Kanadevia
INOVA

Requirement 2 Detailed Design: Work No.1,1A, 2A and 2B the EfW CHP Facility

June 2025

Revision 1.0
Document ref: CP3_R02

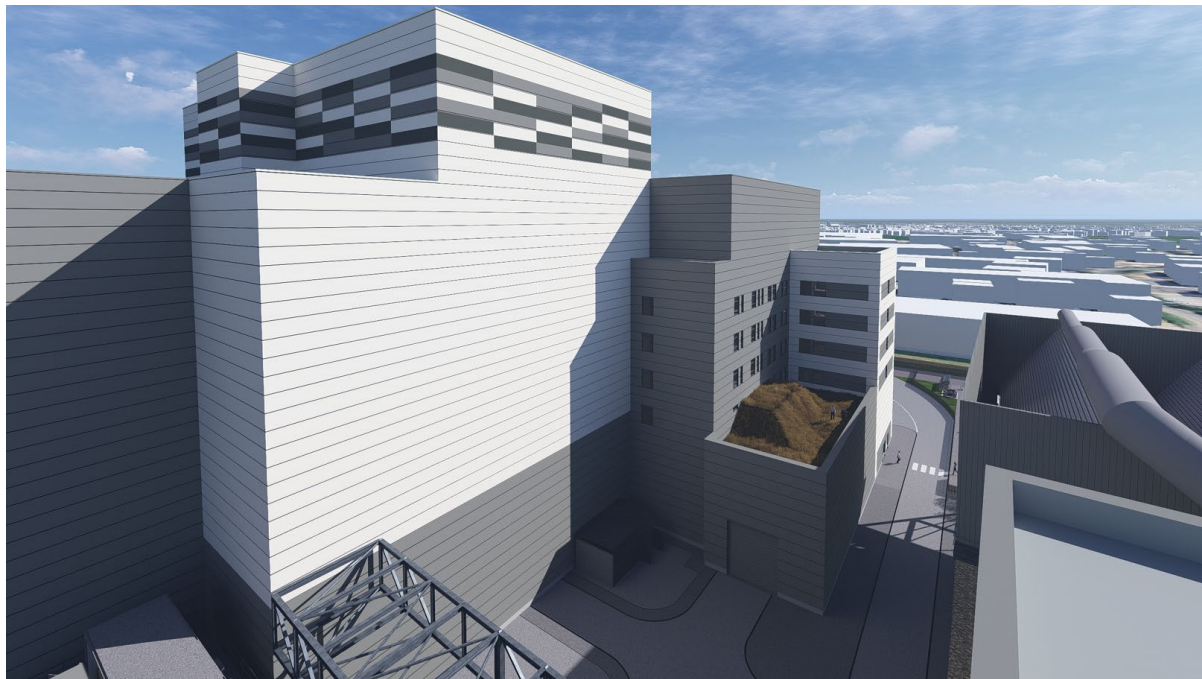
3.6.7

At DU01, windows were incorporated to allow natural lighting into staff, visitor, and community areas. To minimise visual impact, the design retains the concept of punched windows in keeping with the original proposal. A refined composition of darker grey banding articulates the façade, subtly breaking down its mass and scale. This treatment evokes the rhythm and continuity of a ribbon window aesthetic, without resorting to additional fenestration or the use of opaque panels that merely simulate glazing.
